HISTORIC DISTRICT COMMISSION

CERTIFICATE OF APPROPRIATENESS

Application Number: HDC2026-00106

Project Address: 264 Watson

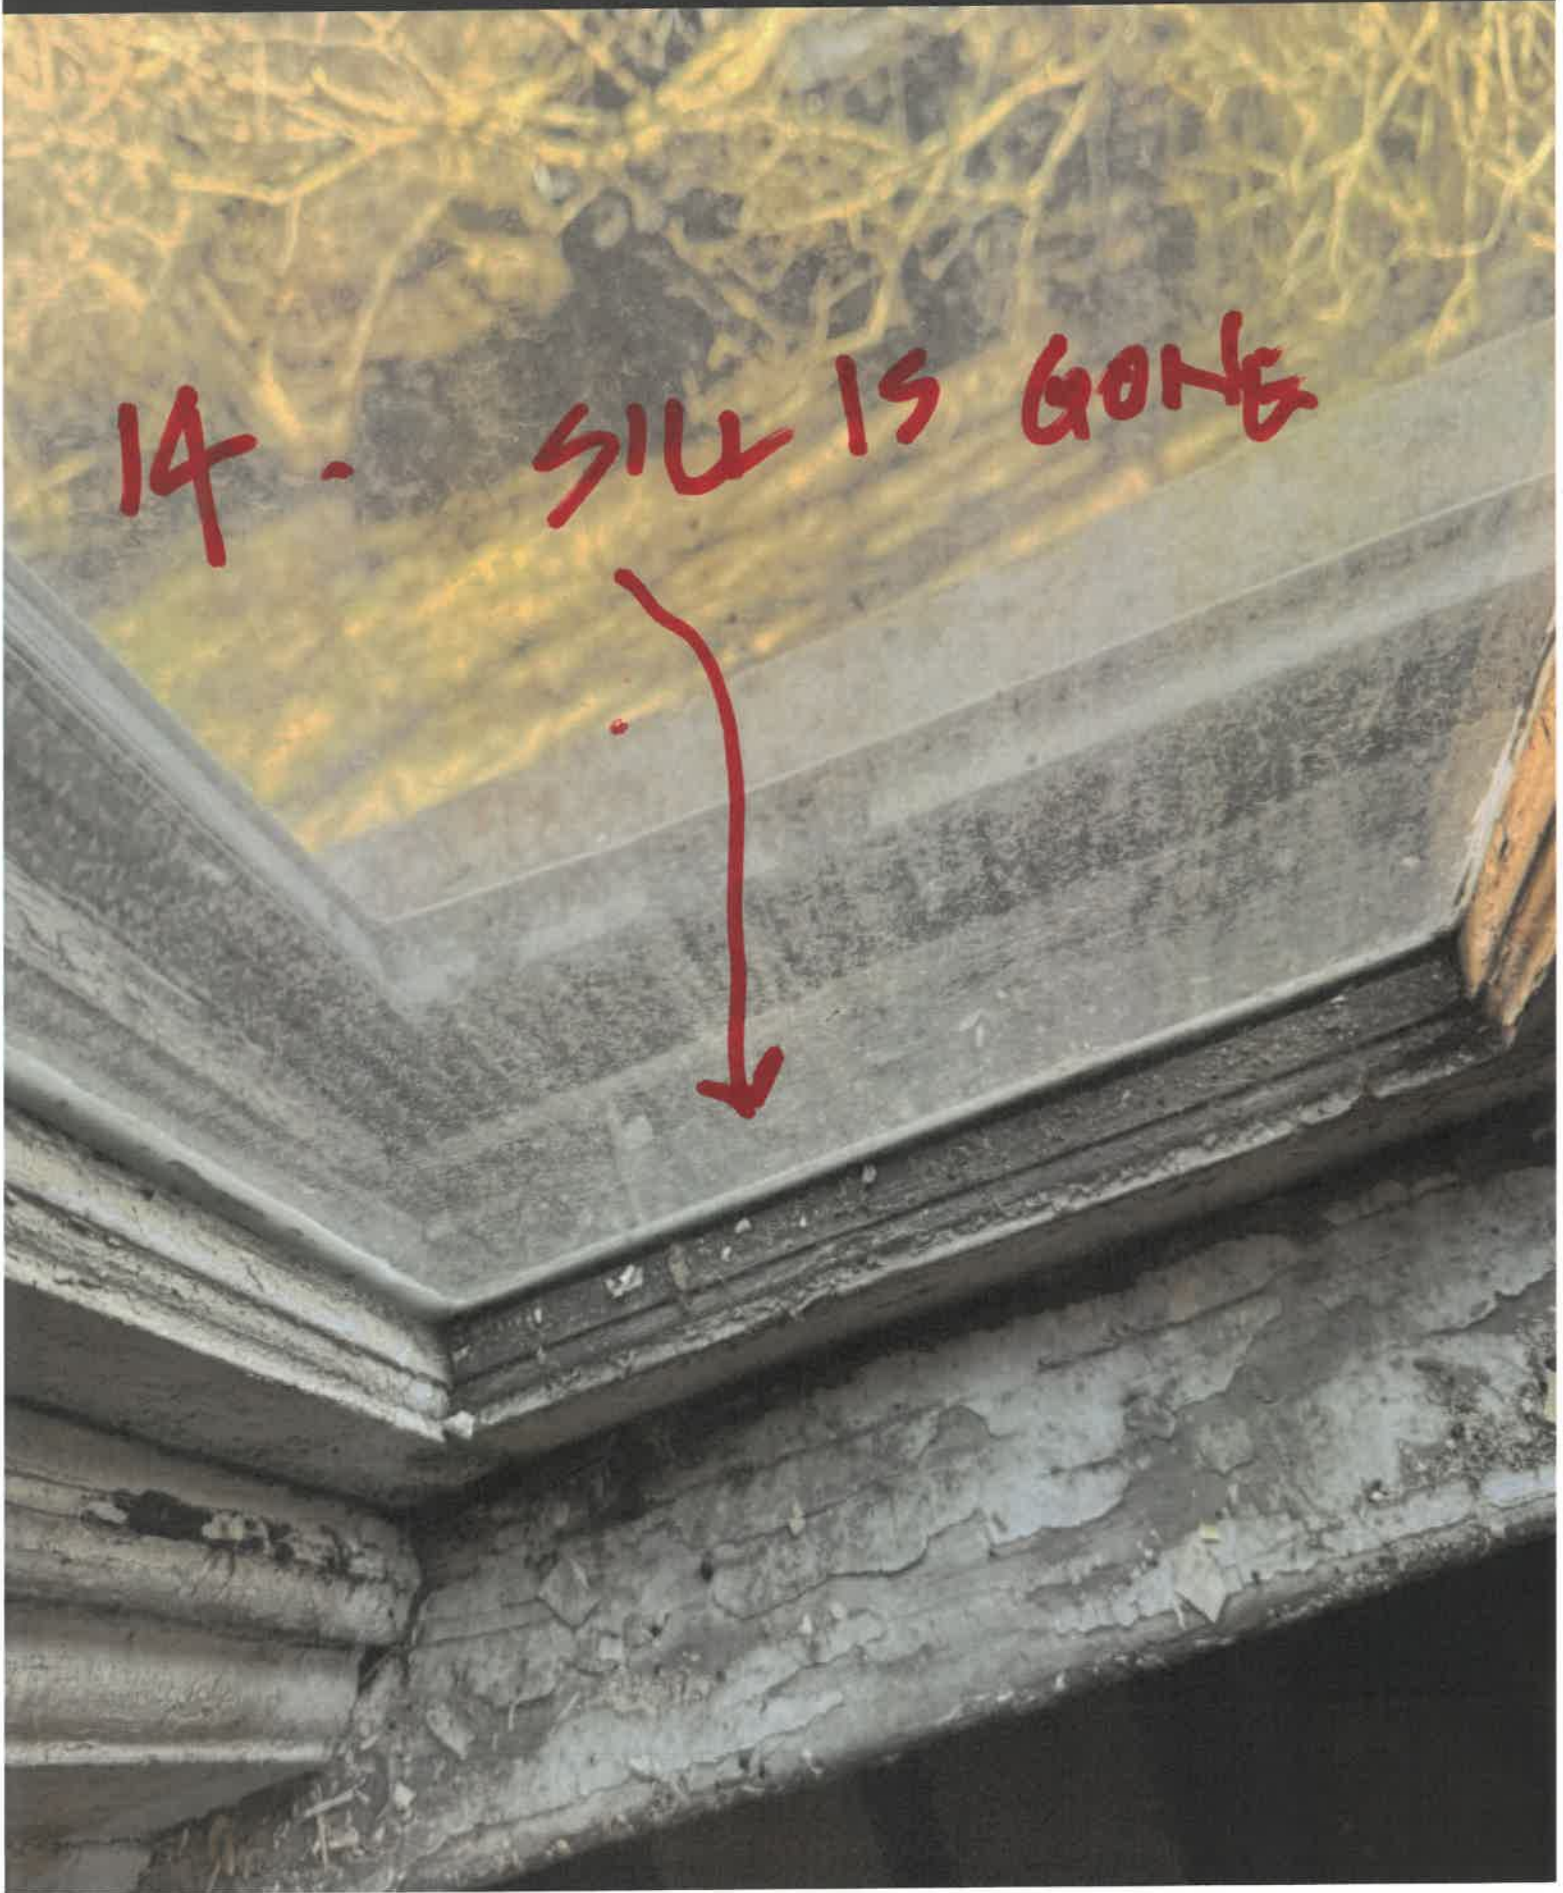
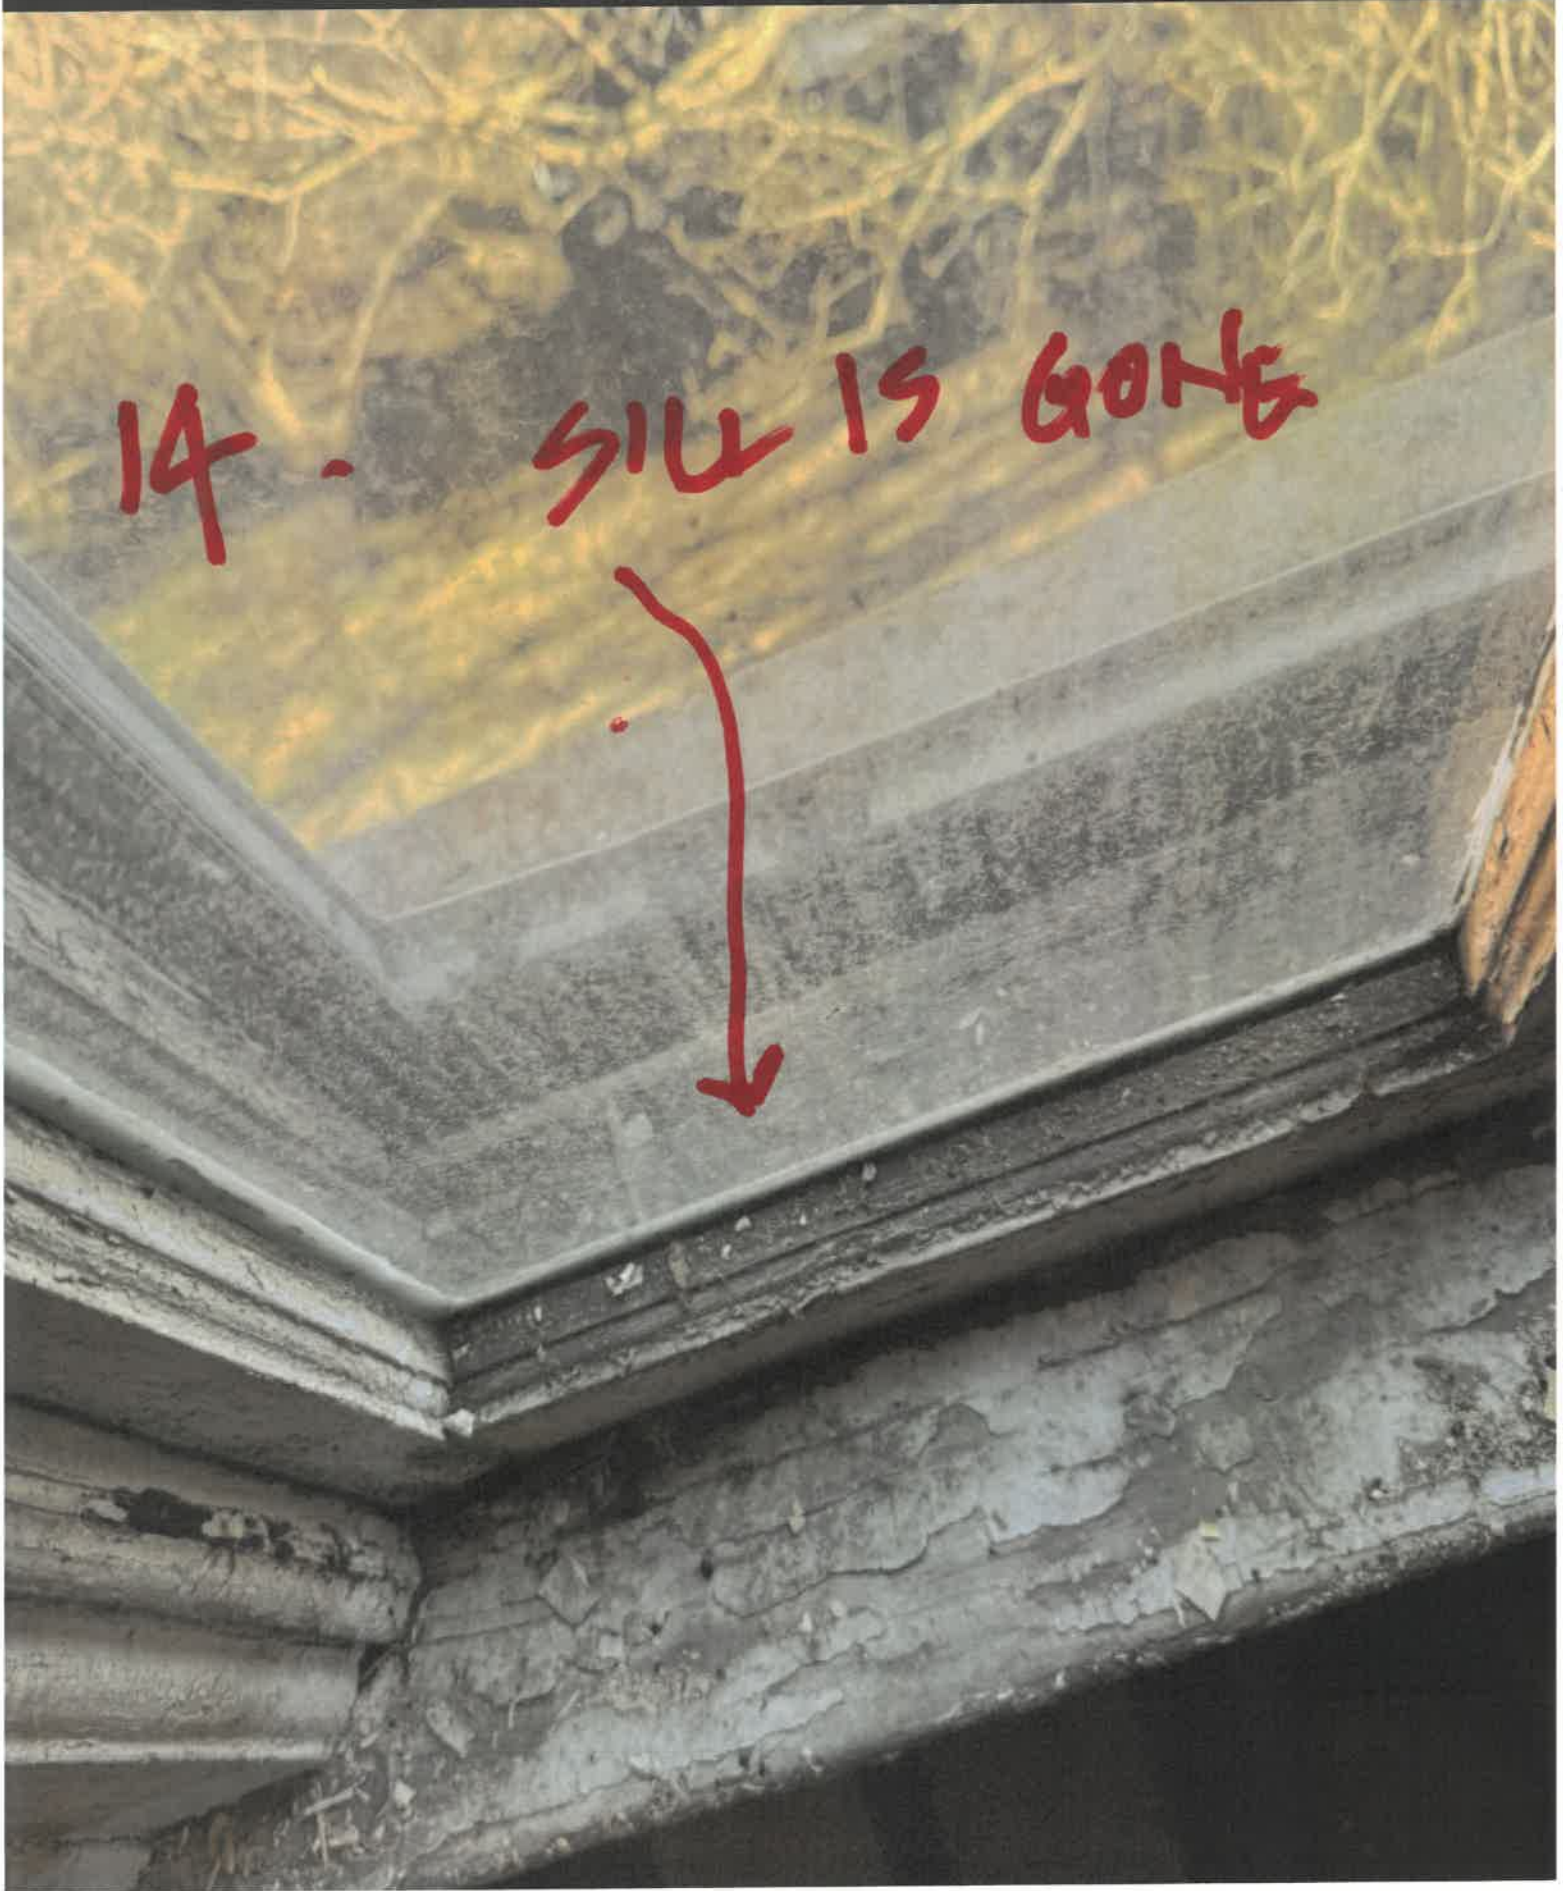
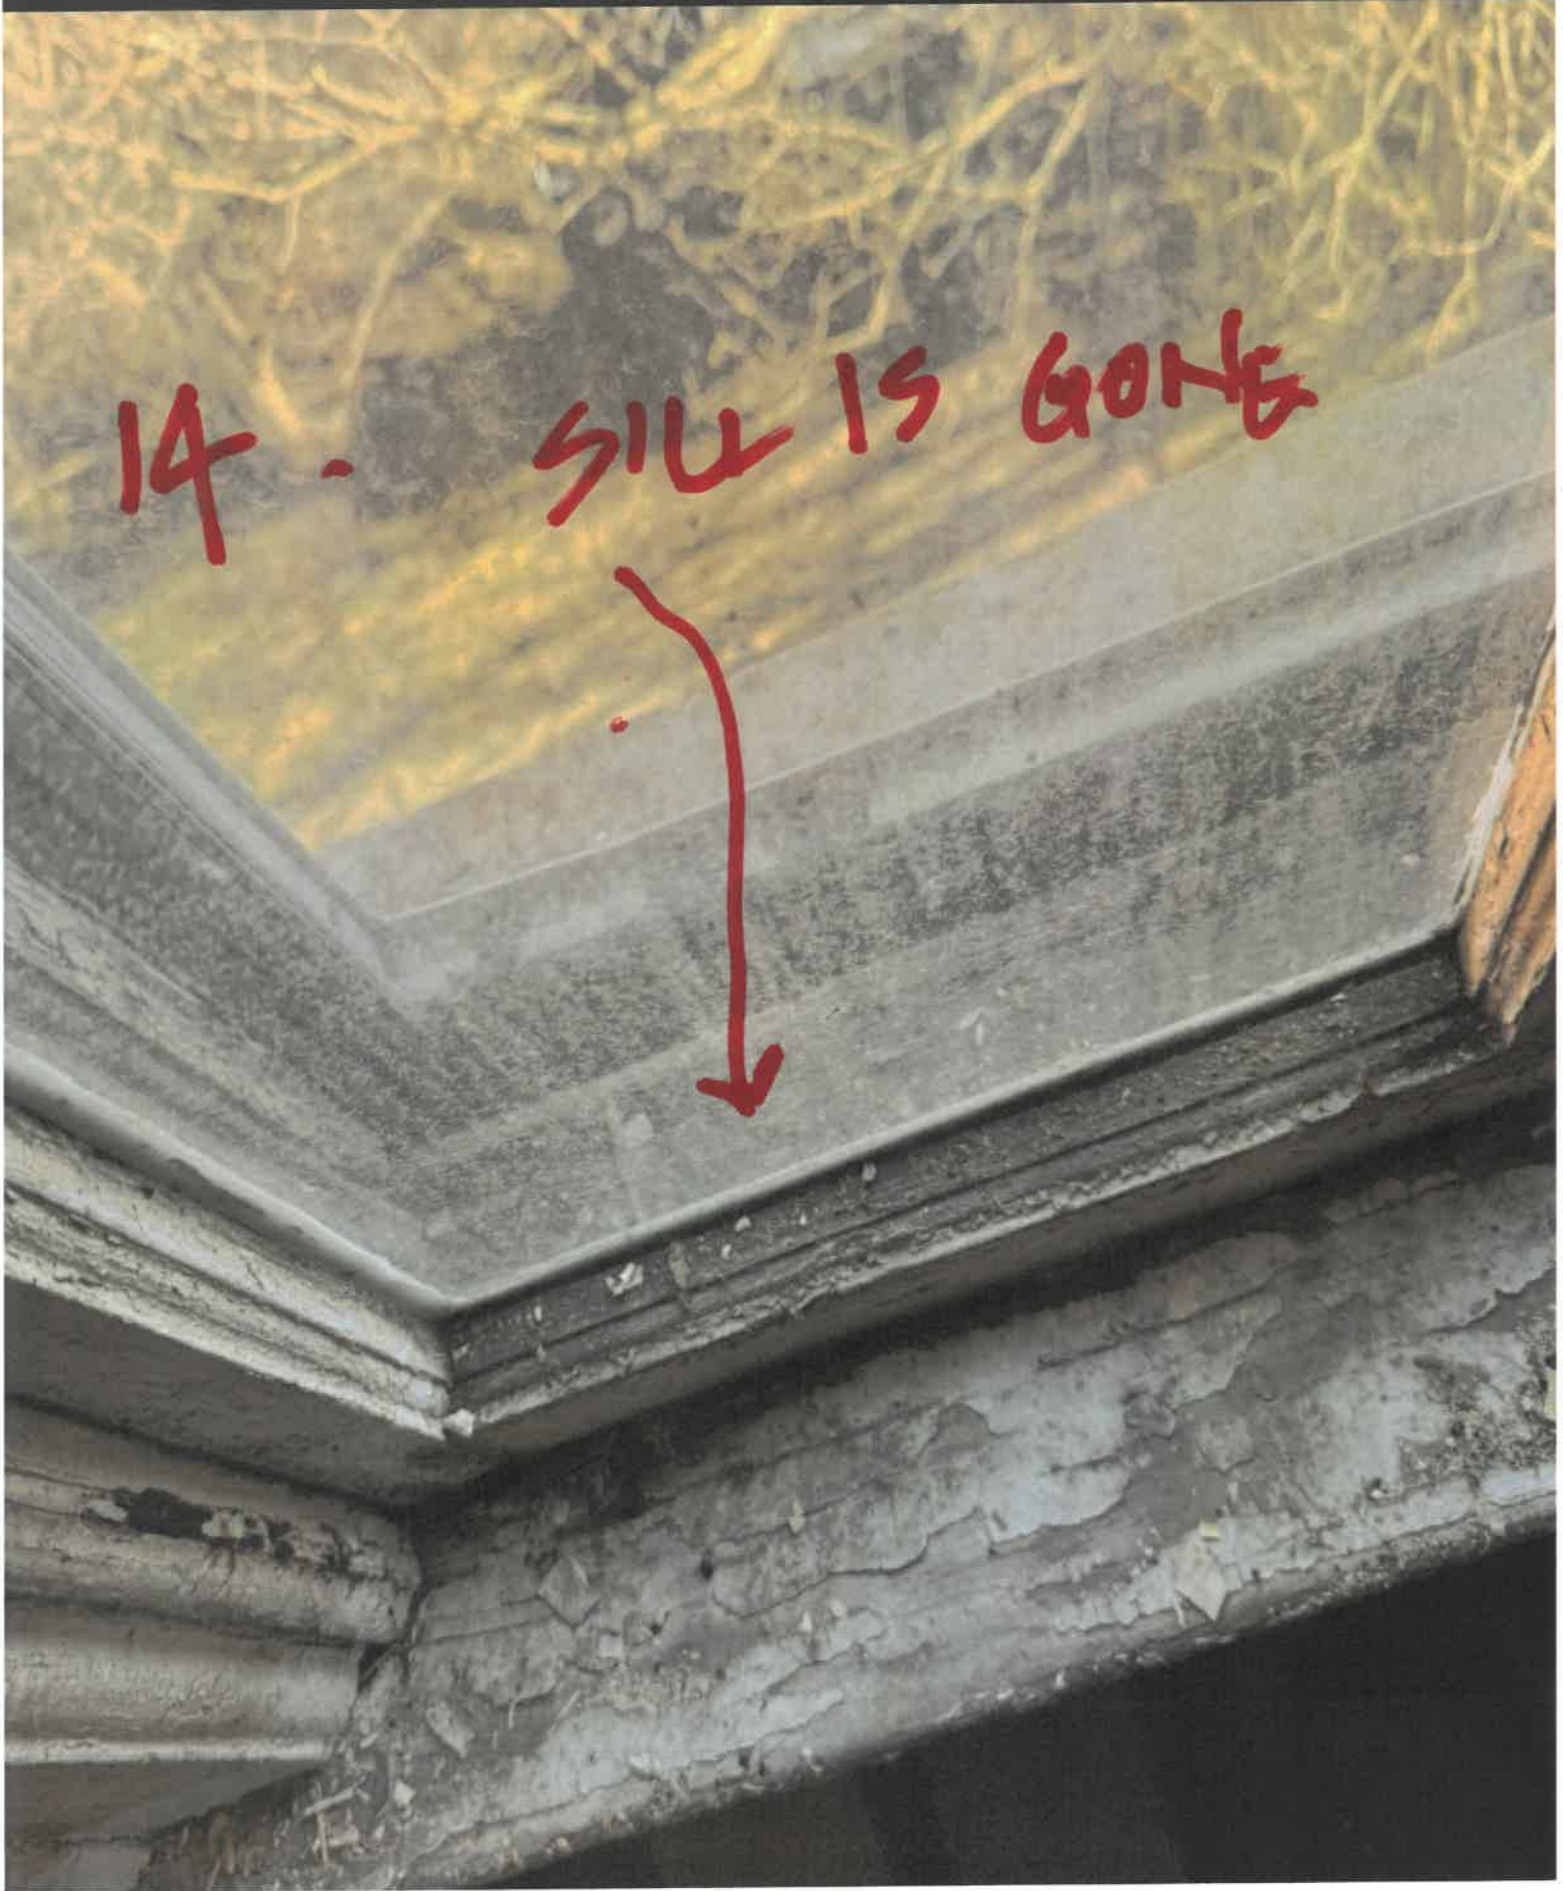
Location and/or line (mark) #	Frame and Exterior casing Integrity, Water tight condition	Sash Integrity / Glass condition	Recommendation
Windows 14 and 15 at the kitchen	Frames and exterior casings are dry-rotted to a point where any repair will not be a lasting repair.	Structurally the sash have lost their structural integrity; any repair attempt is unlikely to have lasting effect.	Recommend repair of framing, blocking up the opening to accept a new insert window. Replace rotted casing.
Window 18 @ Office	This frame and exterior flat casing is rotted at the bottom corners, which is allowing water, animals, and insects to penetrate the home.	Structurally the sash is broken/damaged—and—is missing part of its divided lite component. Even with the storm it is unlikely this window will have lasting effect.	Recommend repair of framing, blocking up the opening to accept a new insert window. Replace rotted casing.

Window 21 in stairs	This frame and exterior flat casing is rotted at the bottom corners, which is allowing water, animals, and insects to penetrate the home. The sill itself is gone was repaired with a piece of brake metal.	These sashes are in the best condition in entire home— however the due to frame and casing being literally dry rotted—recommend replace.	Recommend repair of framing, blocking up the opening to accept a new insert window. Replace rotted casing.
Window 7, 8, and 9	The center window has no existing sashes; the frame and exterior casing has been somewhat protected and isn't as bad as all the others. But since there is nothing to repair/restore @ 8.	Window #8 is missing sashes. Nothing to repair/restore.	Recommend repair of framing, blocking up the opening to accept a new insert window for all 3 openings.
Widow 23B @ Dining	This window is badly damaged — frames and casings. It is well beyond repair—and will directly adjacent to a window replacement @ 29 (currentl a vinyl window).	Structurally the sash have lost their structural integrity; any repair attempt is unlikely to have lasting effect, plus the missing sash (currently plywood-ed over.	Recommend repair of framing, blocking up the opening to accept a new insert window for all 3 openings.

Location and/or line (mark) #	Frame and Exterior casing Integrity, Water tight condition	Sash Integrity / Glass condition	Recommendation
Windows 19 and 20 in E BR	Frames and casings are dry-rotted to a point where any repair will not be a lasting repair. The sills are literally gone.	Structurally the sash have lost their structural integrity; the jointery is failed—any repair attempt is unlikely to have lasting effect.	Recommend repair of framing, blocking up the opening to accept a new insert window. Replace rotted casing.
Windows 16 and 17	These frames and exterior flat casing is rotted at the bottom corners, which is allowing water, animals, and insects to penetrate the home. The sill itself is gone was repaired with a piece of brake metal. Sills are also dry rotted/failed.	These sashes are in the best condition in entire home—however the due to frame and casing being literally dry rotted—recommend replace.	Recommend repair of framing, blocking up the opening to accept a new insert window. Replace rotted casing.

Windows 10,11,12,13,28, 23A, 27 in basement	Appears that these units haven't been painted in decades. Due to being grade they are in a failed condition, completely dry rotted.	Appears that these units haven't been painted in decades. Due to being grade they are in a failed condition, completely dry rotted.	Recommend repair of framing, blocking up the opening to accept a new insert window for all 7 openings.
